# FINAL DRAINAGE REPORT

**UTE PASS STORAGE  
8775 W. HIGHWAY 24, CASCADE, CO**

JPS Project No. 111704  
PCD Project No. PPR-18-\_\_\_

PPR 18-028

**HISTORIC DRAINAGE PLAN**

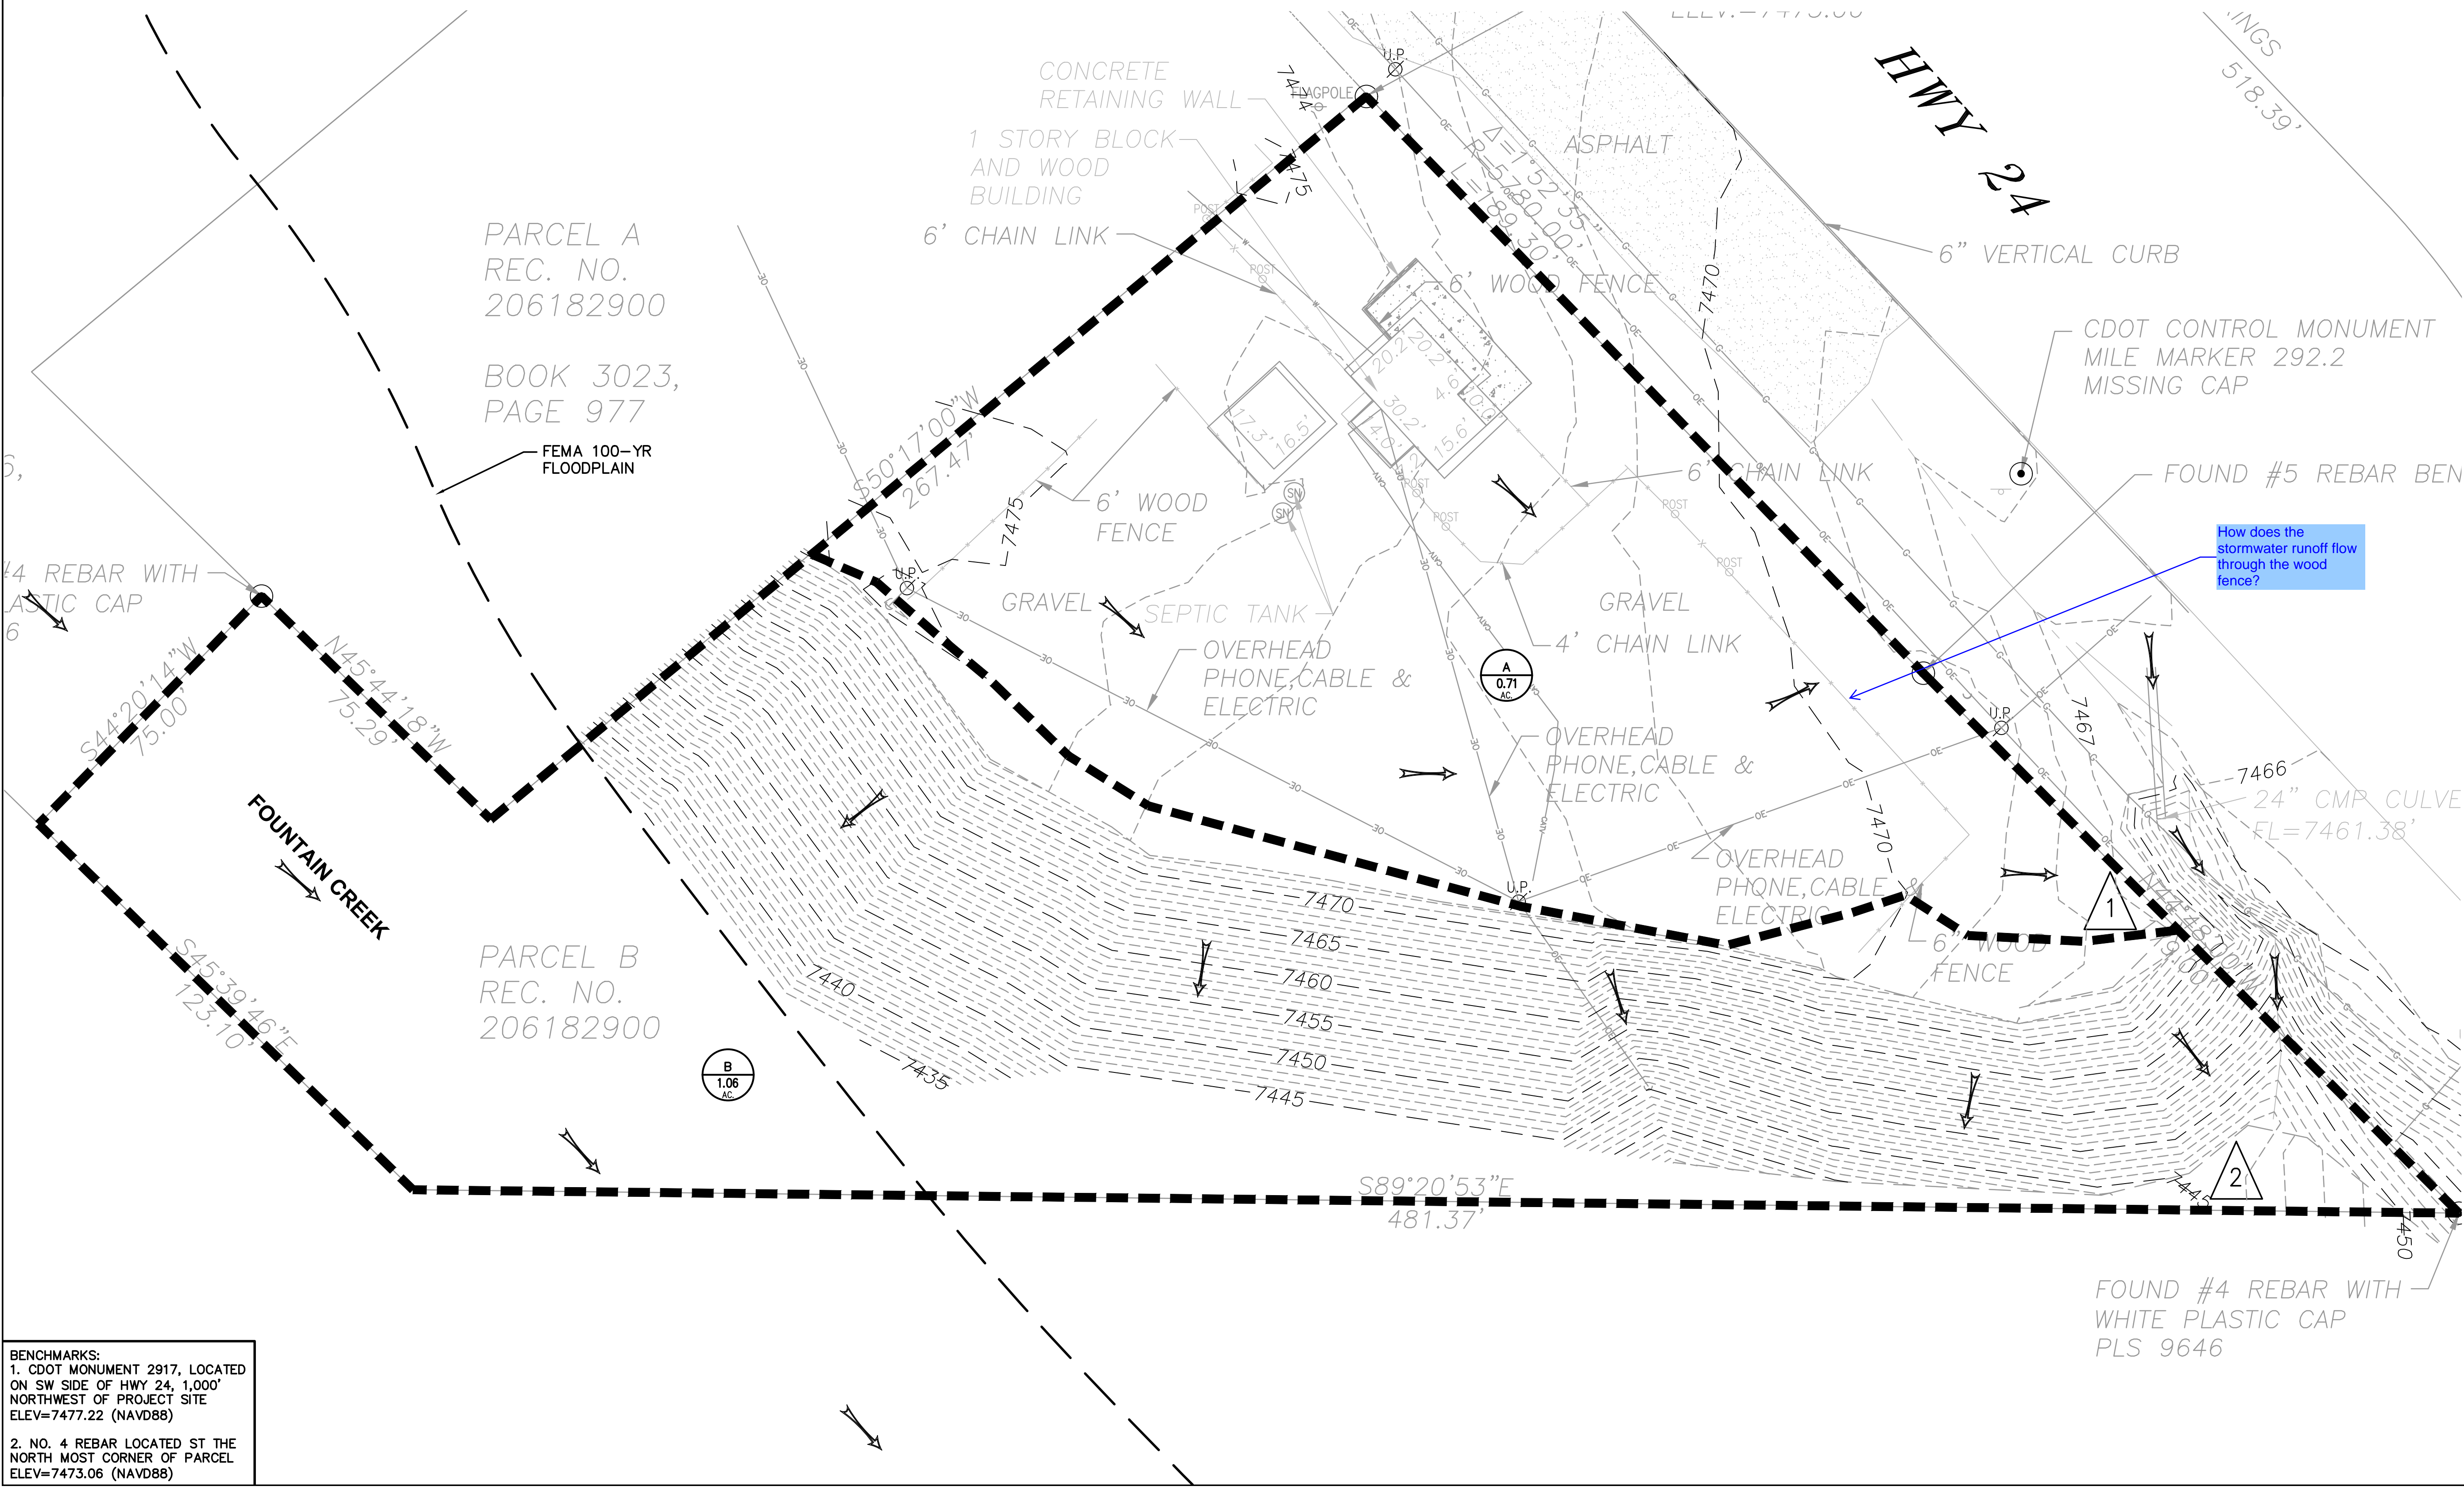
Historic Basin A sheet flows southeasterly towards the existing drainage swale in the southeast part of the site. The existing site within Basin A is developed with two commercial buildings and the site is covered by compacted gravel. Historic drainage from Basin A flows to Design Point #1, with peak flows calculated as  $Q_5 = 1.9$  cfs and  $Q_{100} = 3.7$  cfs. please describe where the flow goes after design point 1.

How does the stormwater runoff flow through the wood fence?

**DEVELOPED DRAINAGE PLAN**

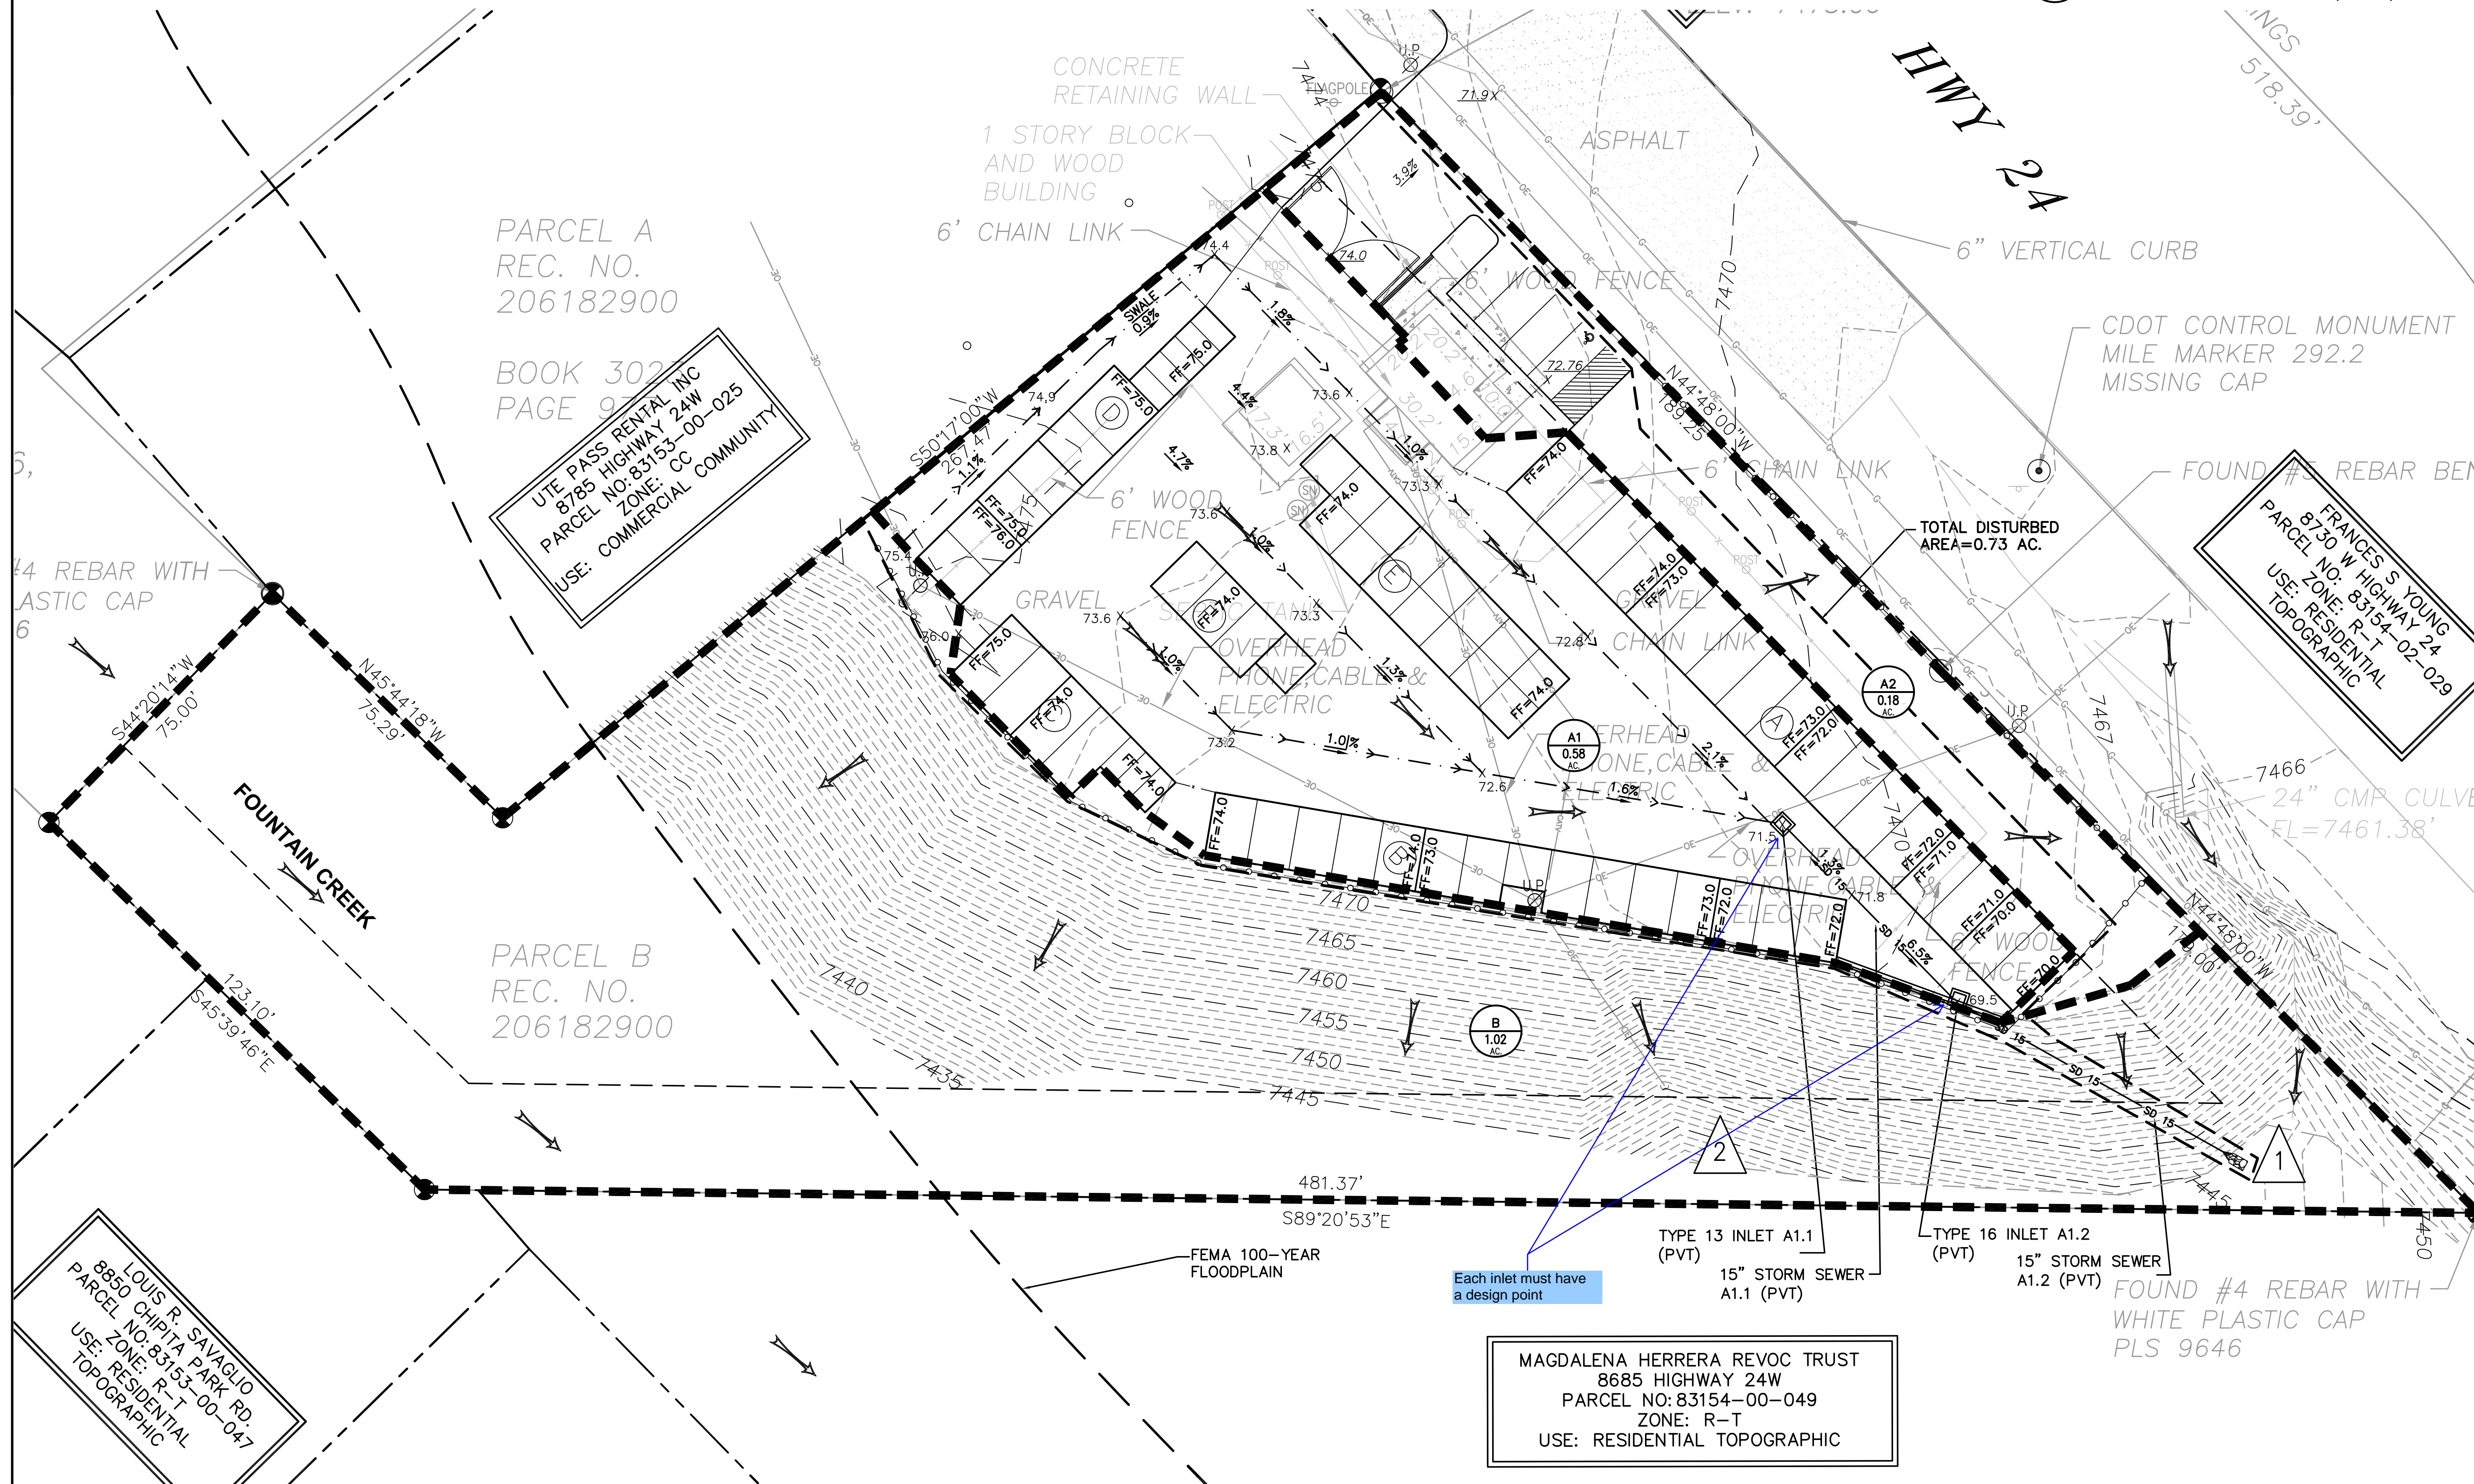
Please show on the drainage map where design points A1 and A2 are located.

Please show enough information so that the reviewer can understand where the flow goes after leaving your property. It appears as if the FES is pointing right at the adjacent property's driveway then to their home. please show floodplain.

Each inlet must have a design point
